ADDENDUM #3

BID: 629

**New HVAC Modernization
For
Adolfo Camarillo High School**

ADDED TO A1.01

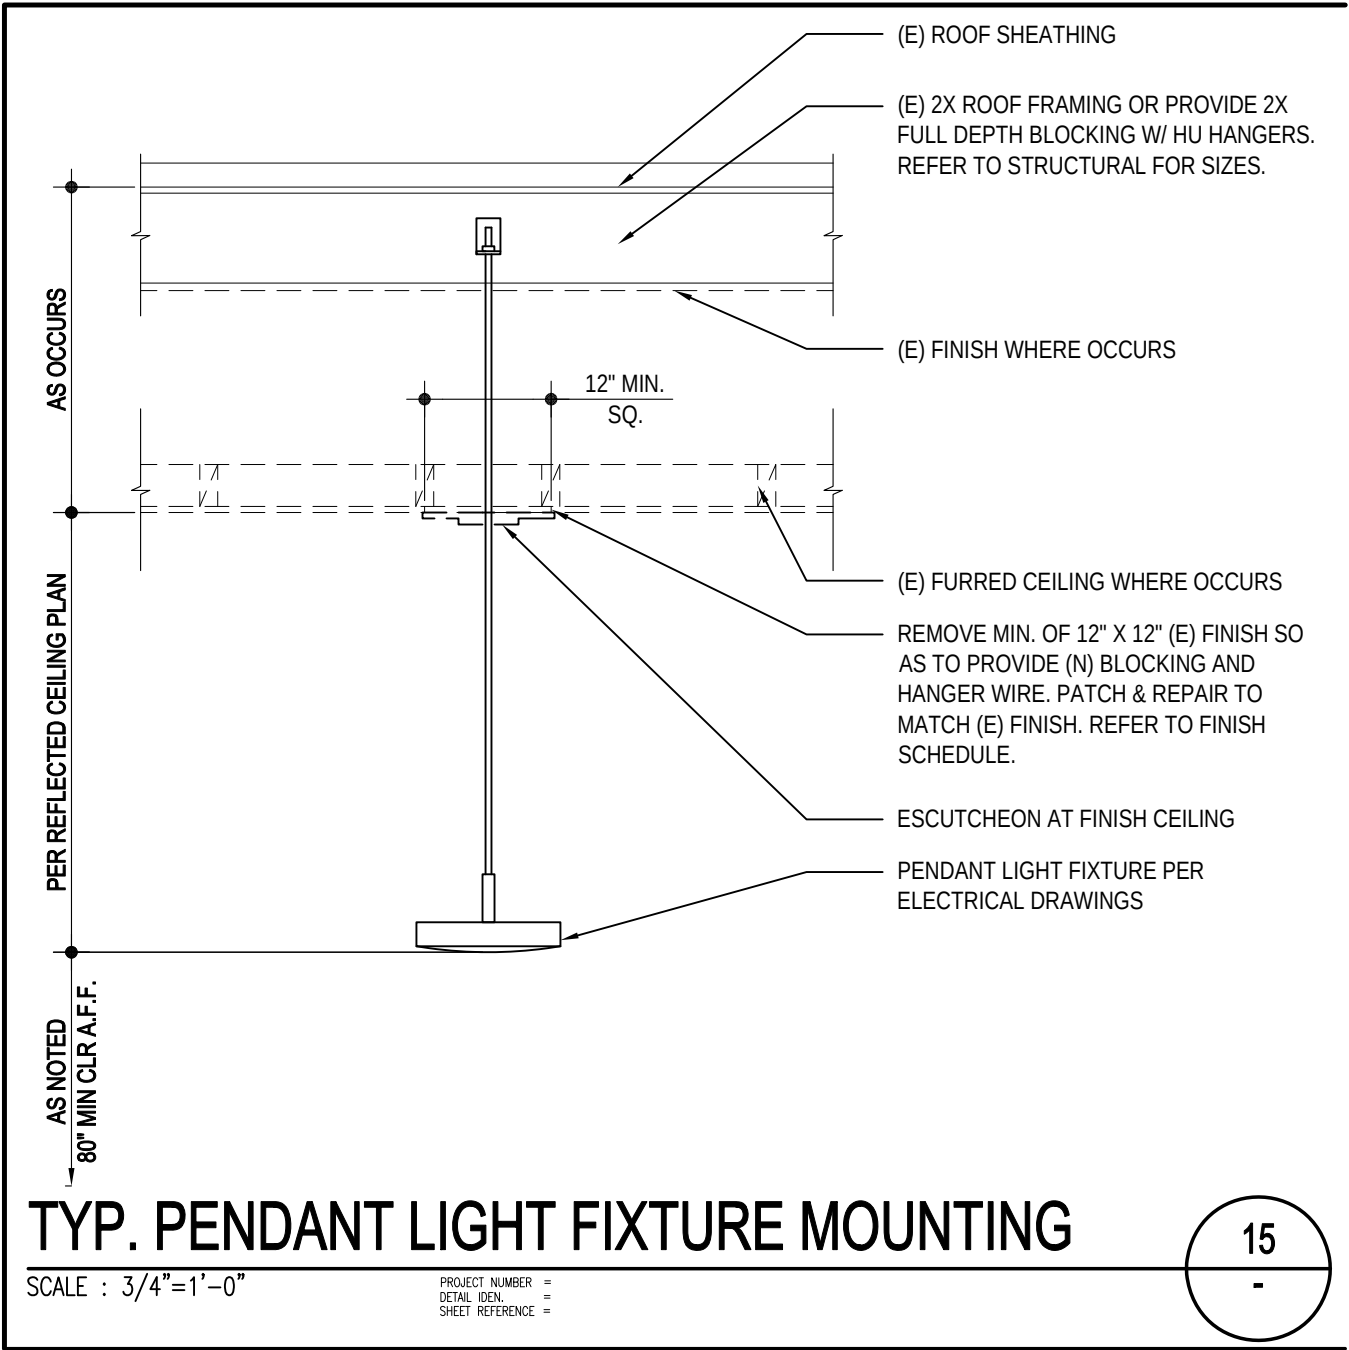
2. **Sheet A1.01**
 - a. **Add** note: "G.C. shall Patch & Repair existing built up roof membranes & existing roof shingles affected by project scope. Refer to Roof Type Table for roof type at each building. Provide a separate square foot unit cost for cover board, insulation board, and sheathing replacement." See attachment 1B.

(E) ROOFING TYPES	
BUILDING	ROOFING TYPE
AQUATICS	BUILT-UP
A	BUILT-UP
B	BUILT-UP
C	SHINGLE
D	BUILT-UP
F	BUILT-UP
G	SHINGLE
H	SHINGLE
I	BUILT-UP
J	SHINGLE
K	SHINGLE
L	BUILT-UP
M	SHINGLE
N	SHINGLE
O	BUILT-UP
Q	BUILT-UP
U	BUILT-UP
V	BUILT-UP
W	BUILT-UP
X	BUILT-UP
Y	BUILT-UP
COVERED WALKWAY	BUILT-UP

ATTACHMENT 2
ADDED DETAILS SHEET A9.01

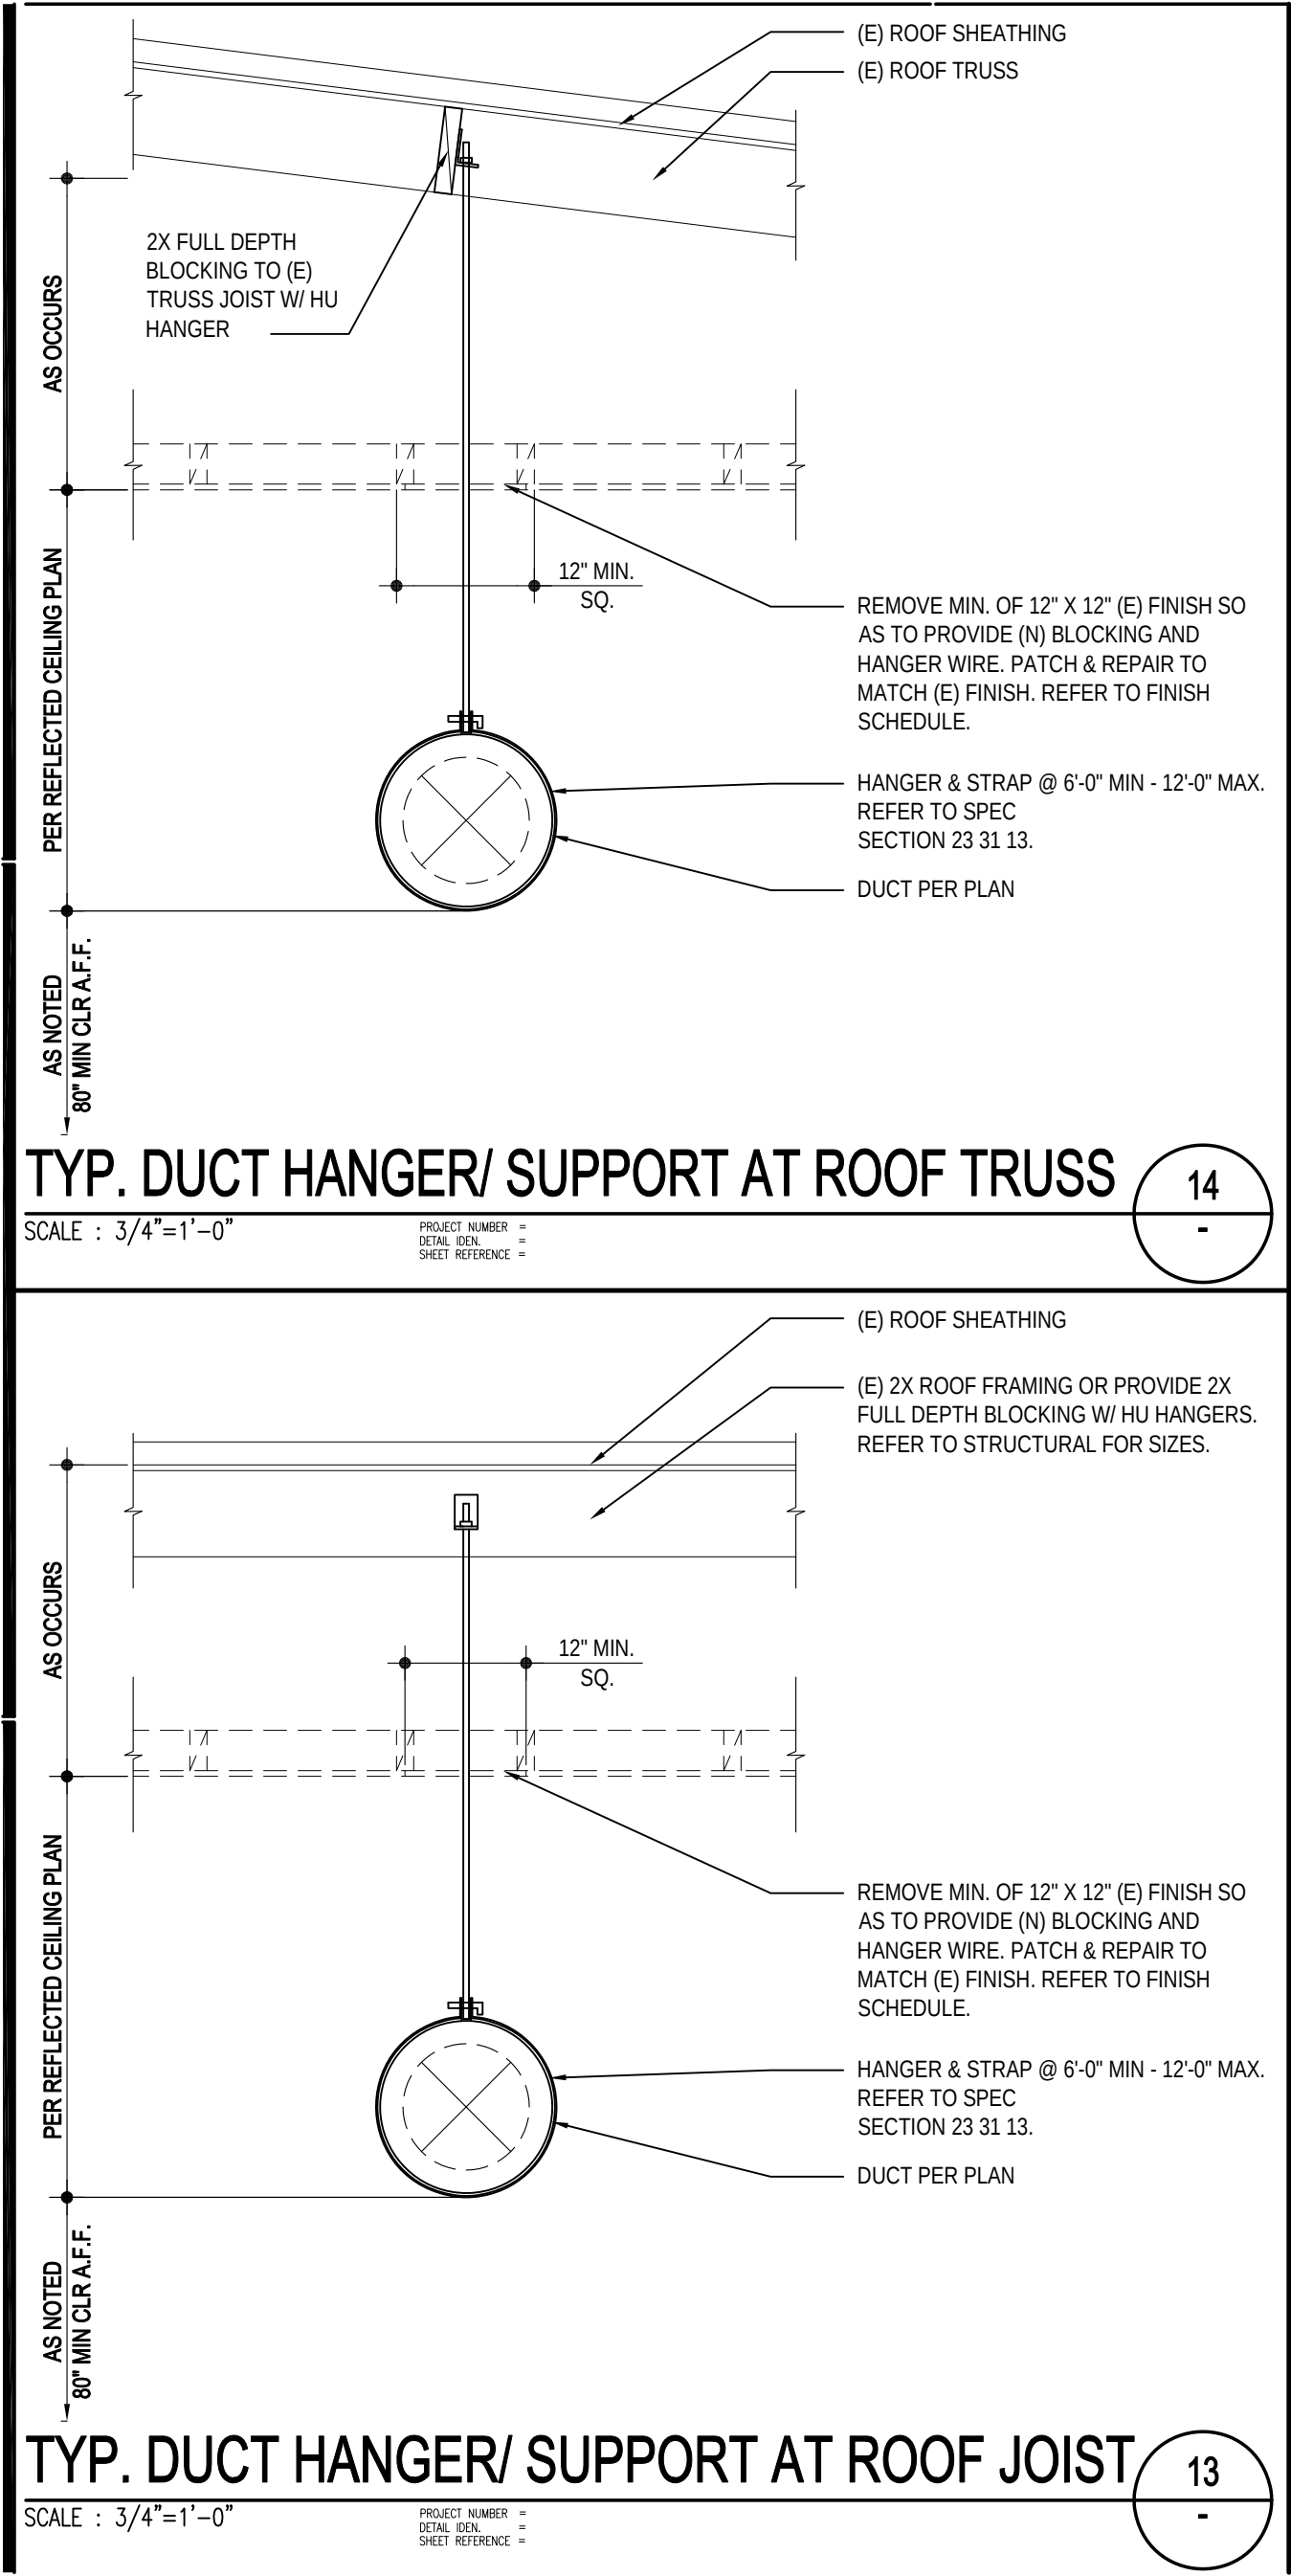
13. **Sheet A9.01**
 - a. **Add** typical details 13/-, 14/-, and 15/-. See attachment 2 and 3. Details shall be considered typical and shall be used throughout project whether specifically referenced or not.

ATTACHMENT 4
ADDED DETAILS SHEET A9.02

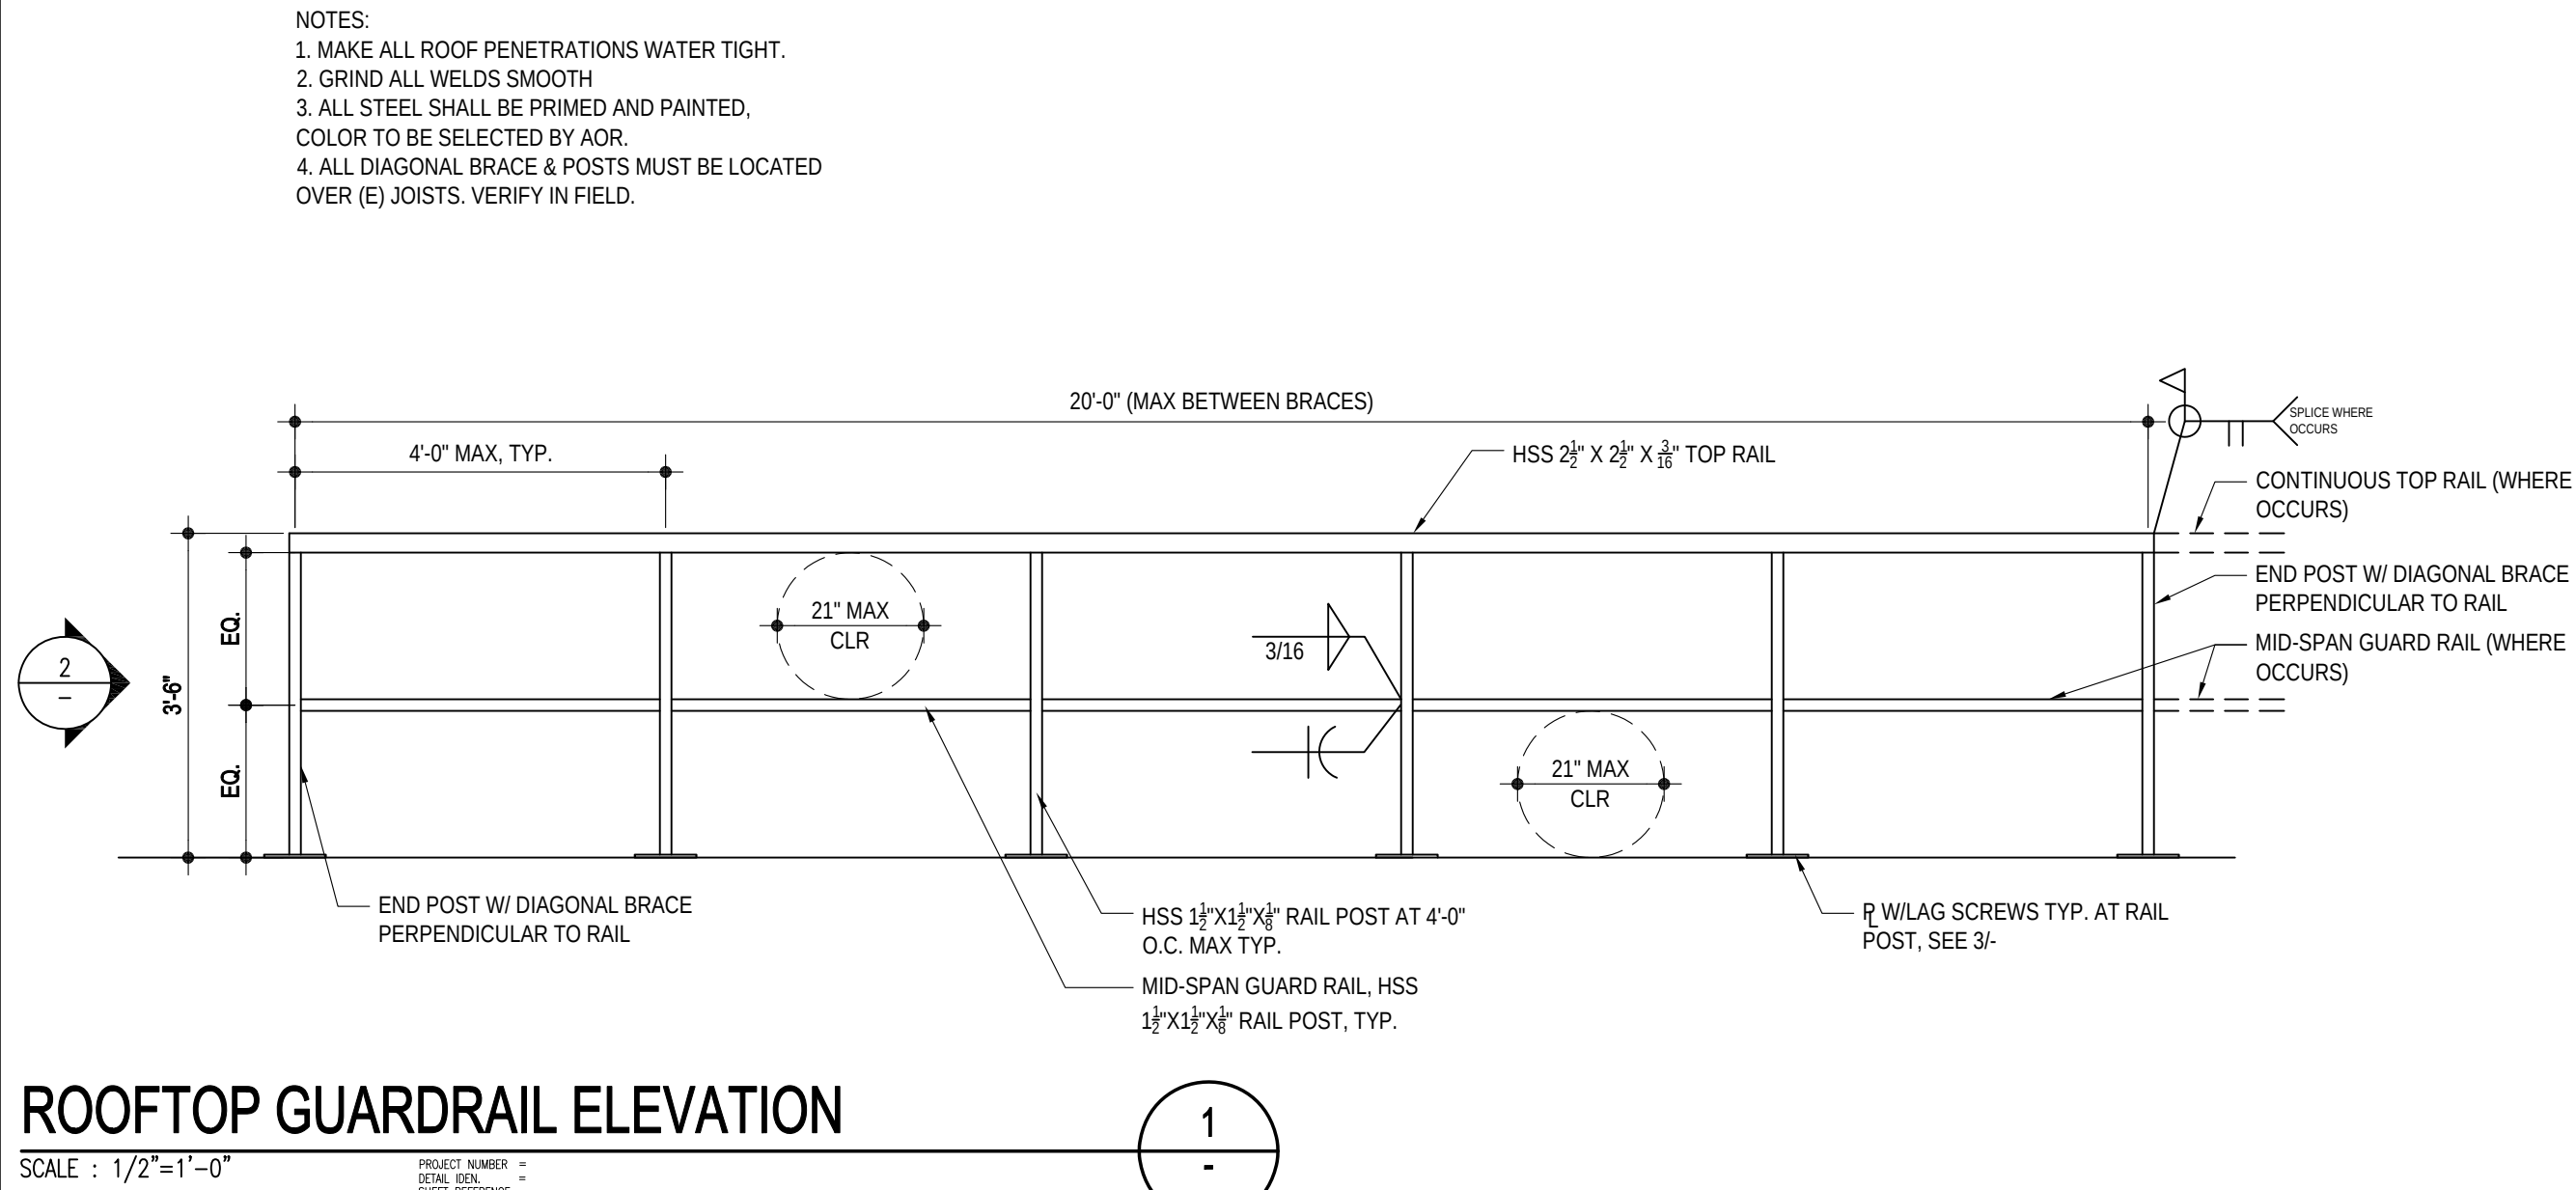
14. **Sheet A9.02**
 - a. **Revise** detail 9/- Typ. Platform Section to read " 8" min" instead of " 6" min."
 - b. **Add** details 13/- and 14/-. See attachment 4. Details shall be considered typical and shall be used throughout project whether specifically referenced or not.
